**JURUPA COMMUNITY SERVICES DISTRICT
RIVERSIDE, CALIFORNIA**

ADDENDUM NO. 4

**TO THE PLANS AND SPECIFICATIONS FOR
RECYCLED WATER PROGRAM – SEGMENT 3 FINAL DESIGN
JCSD P.N. C215078**

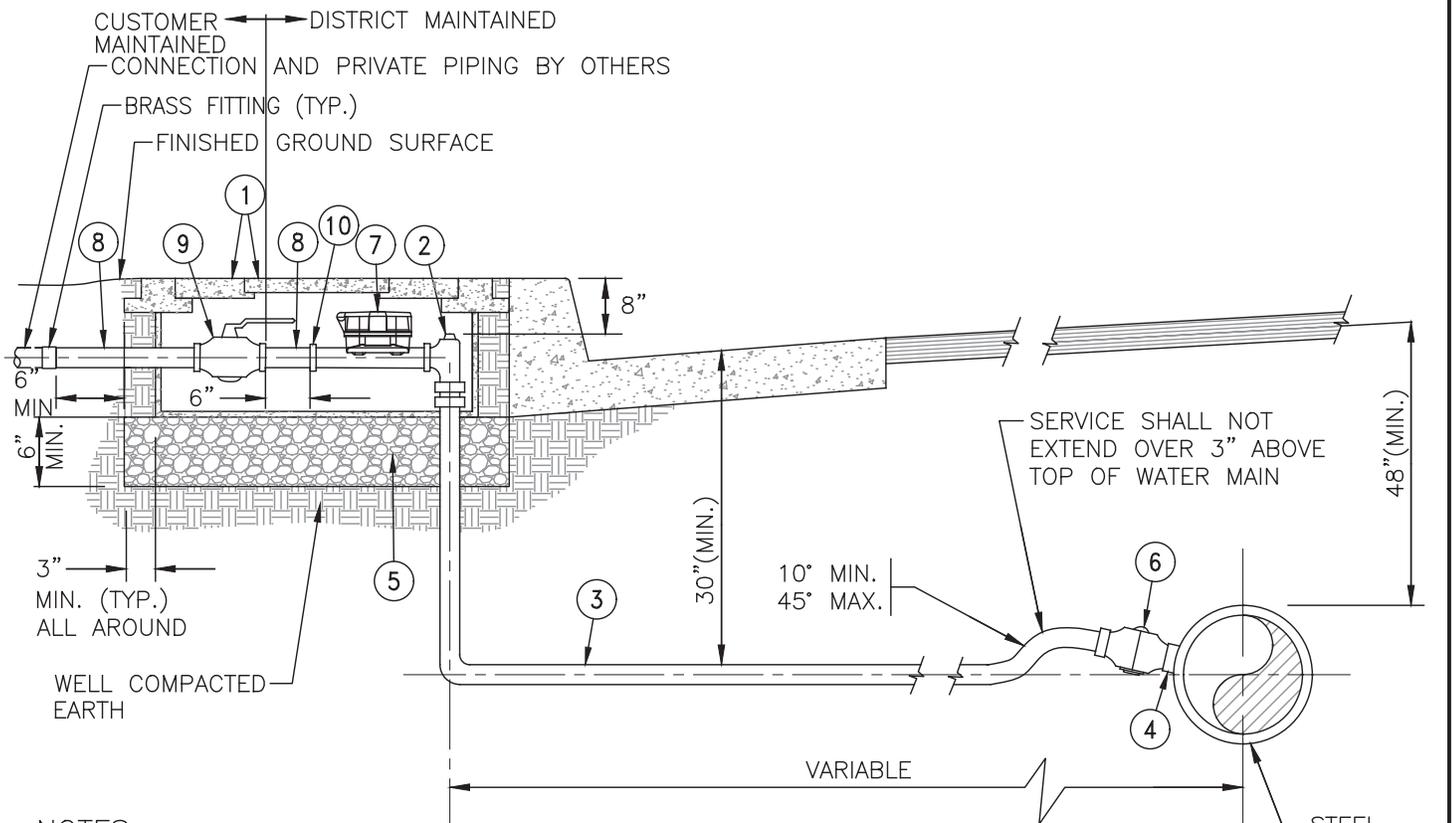
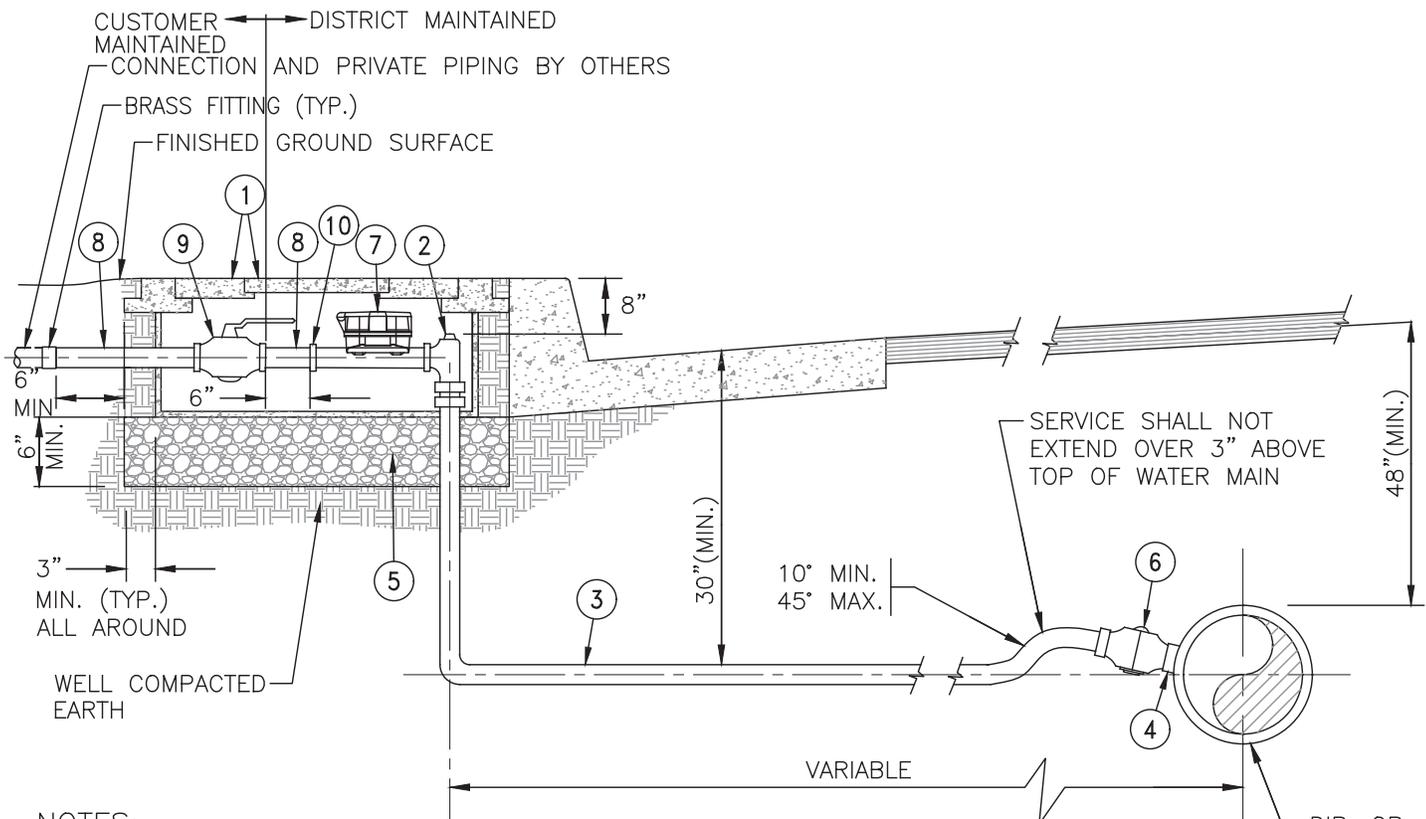
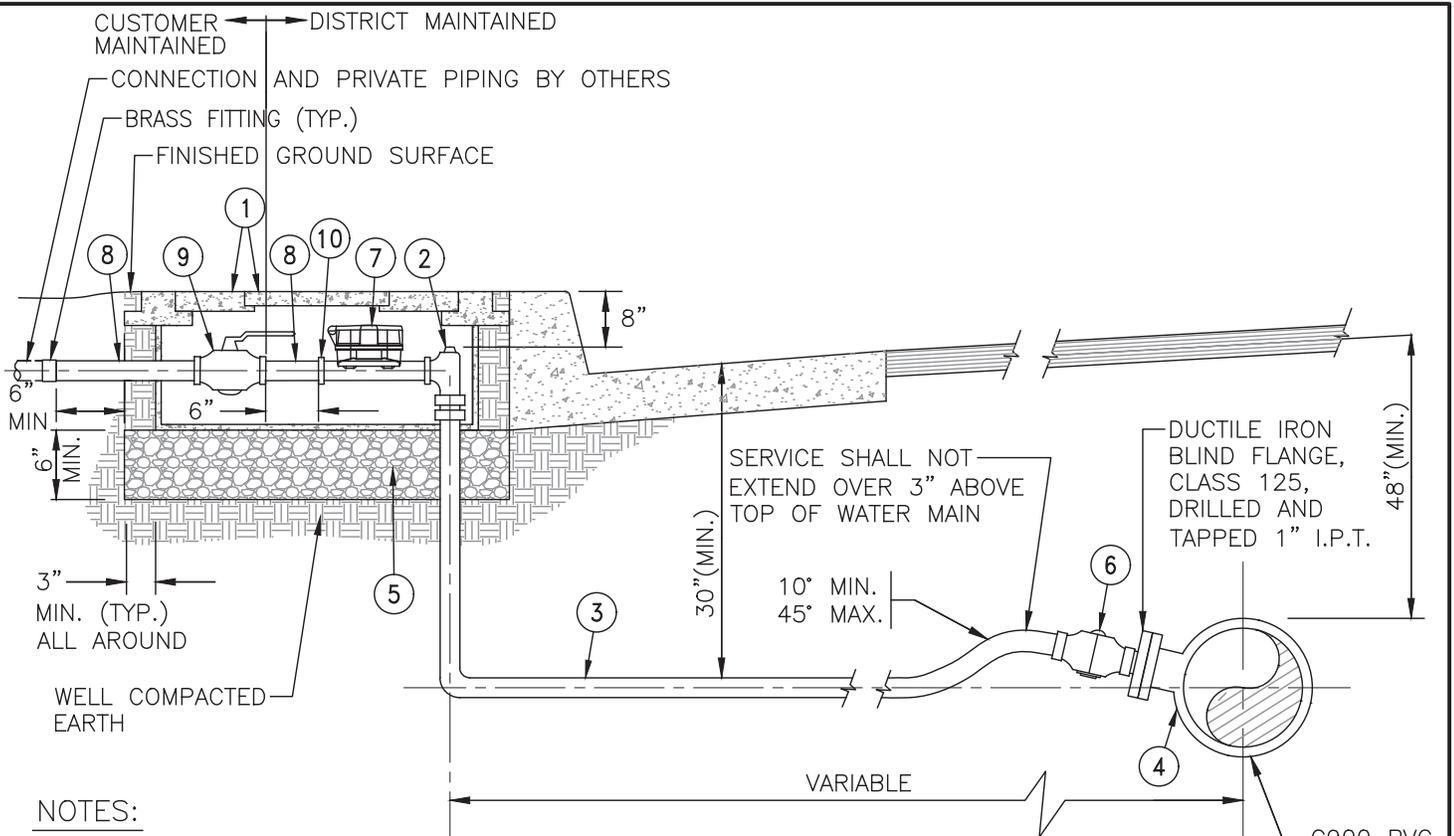
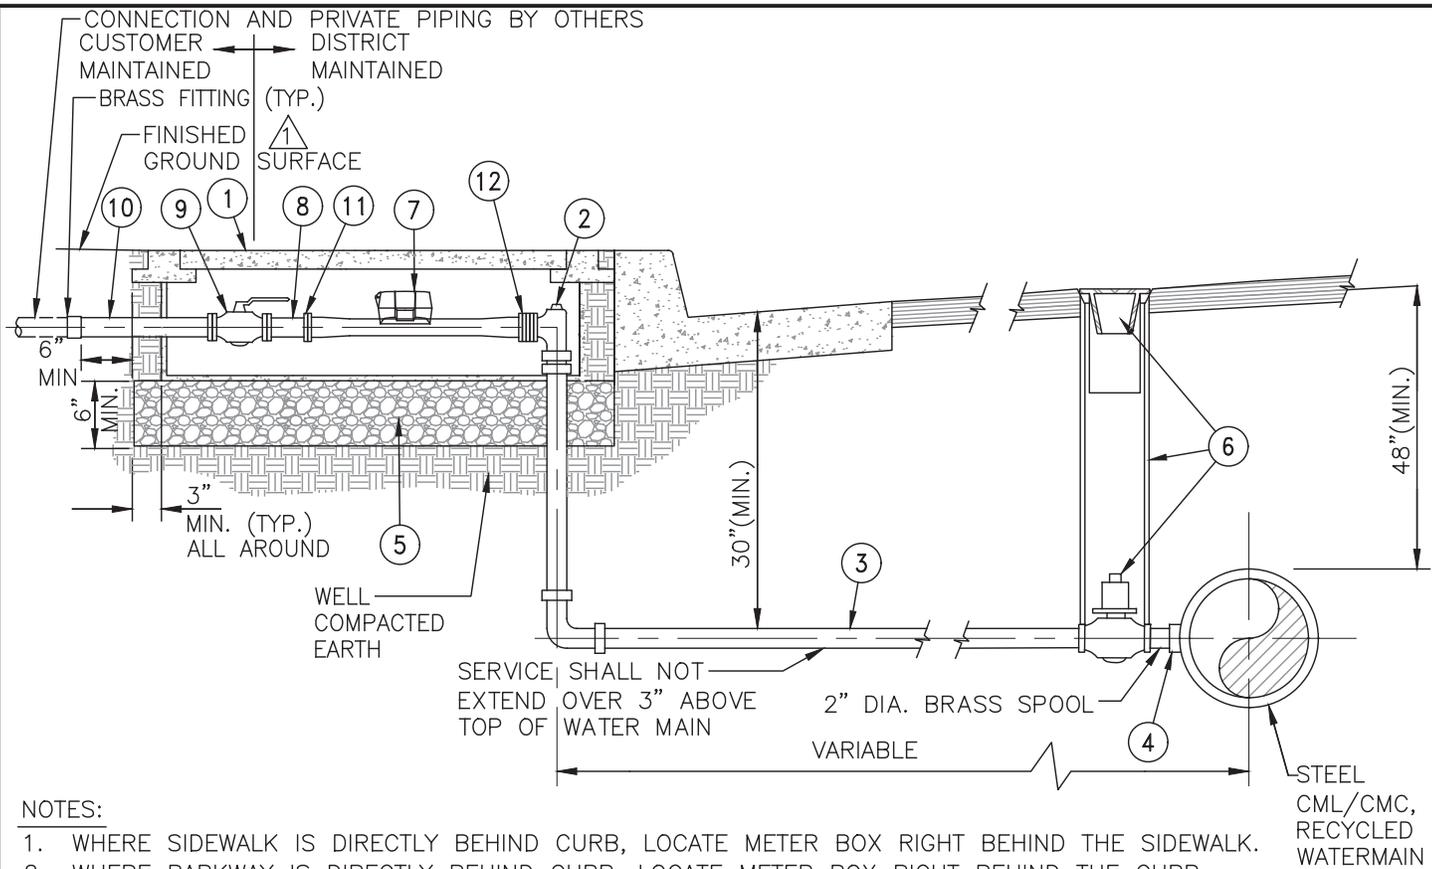
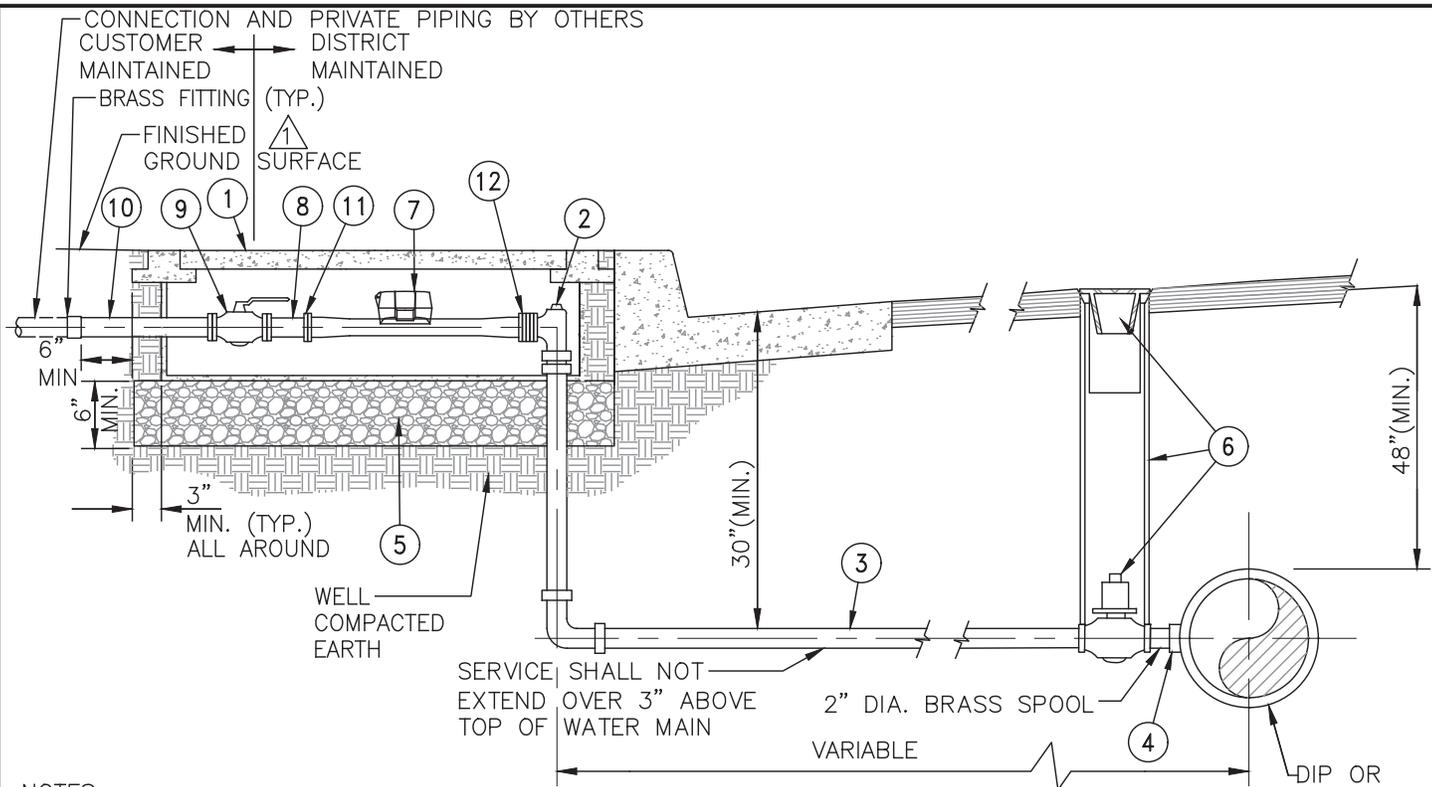
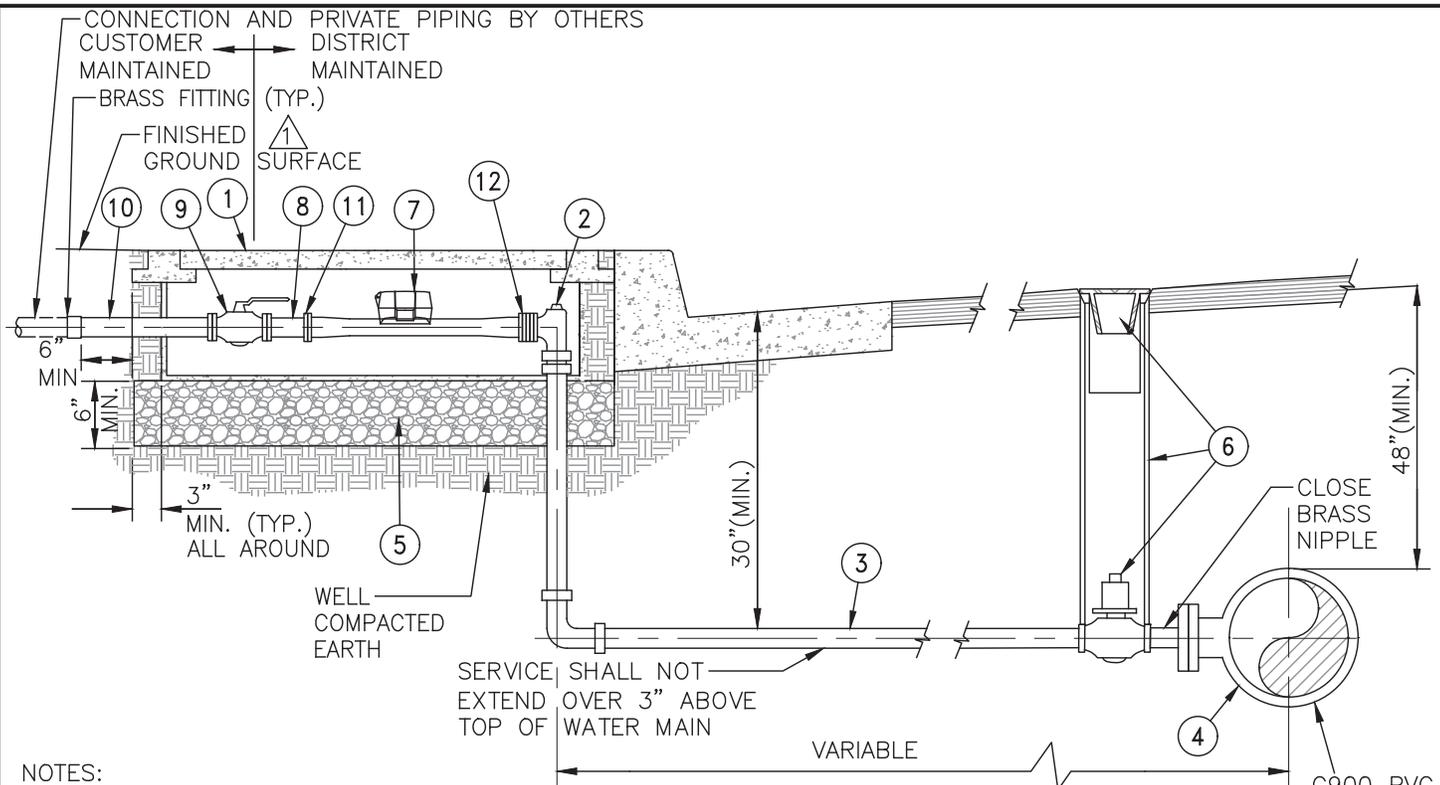
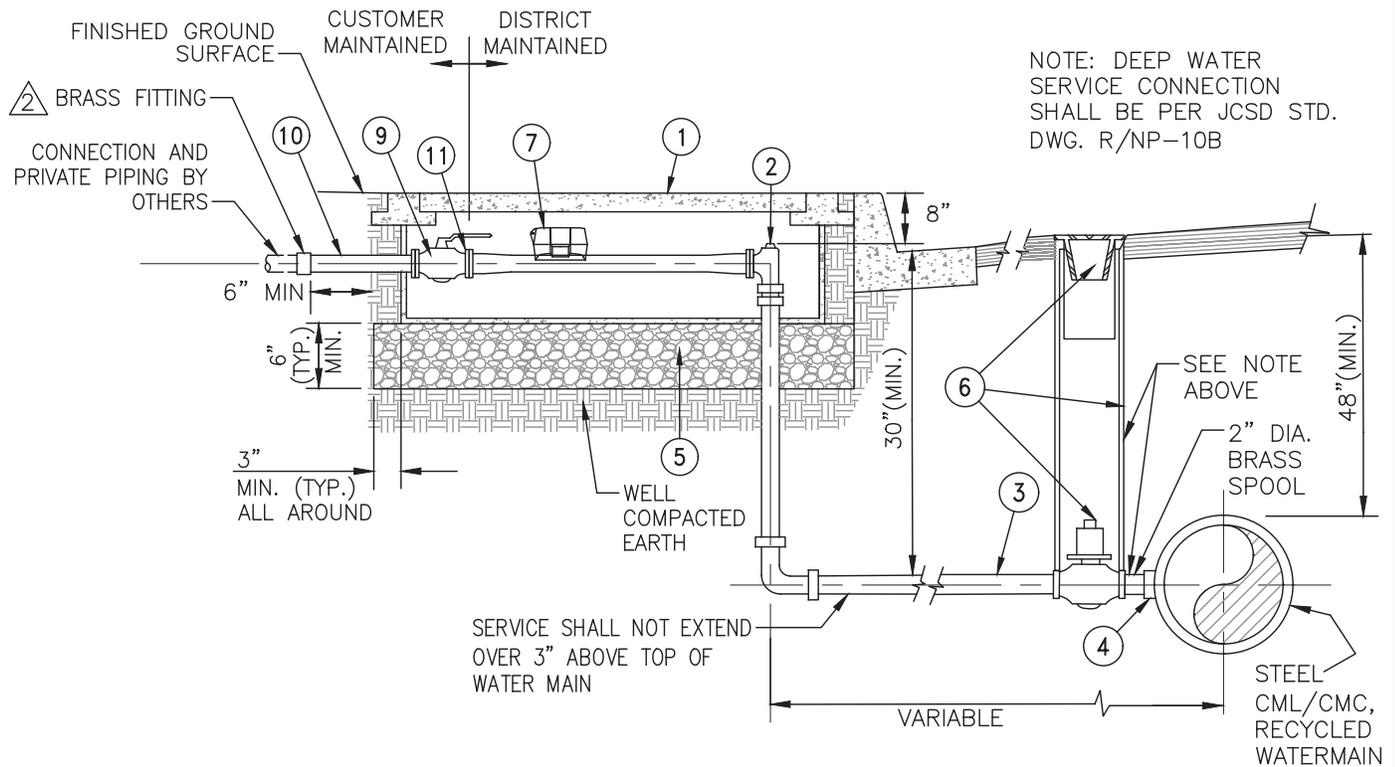
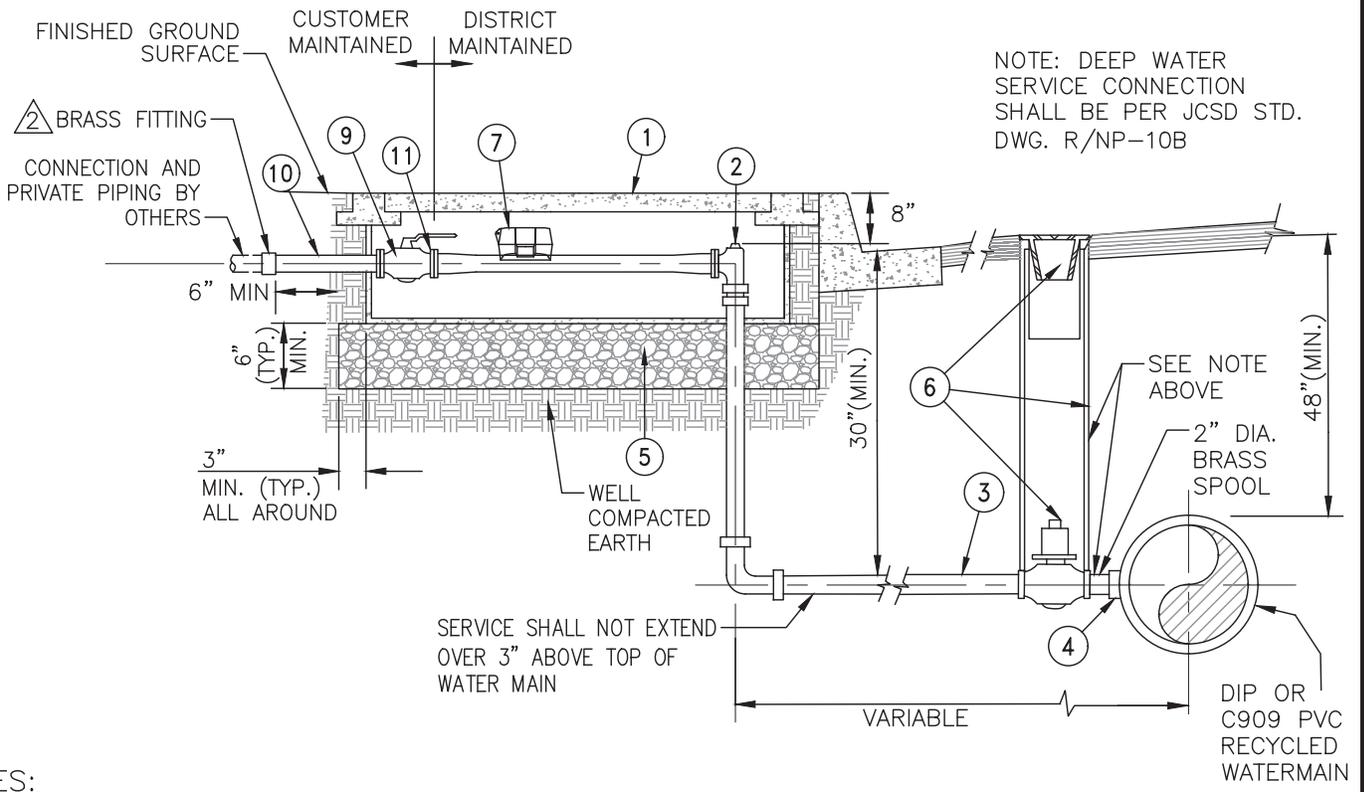
1. Appendix K has been modified to include updated Standard Drawing details for R/NP-8, -8A, -8B, -9, -9A, -9B, -10, -10A, -10B, and -10C. The updated Appendix K section has been included in its entirety in **Attachment C**.
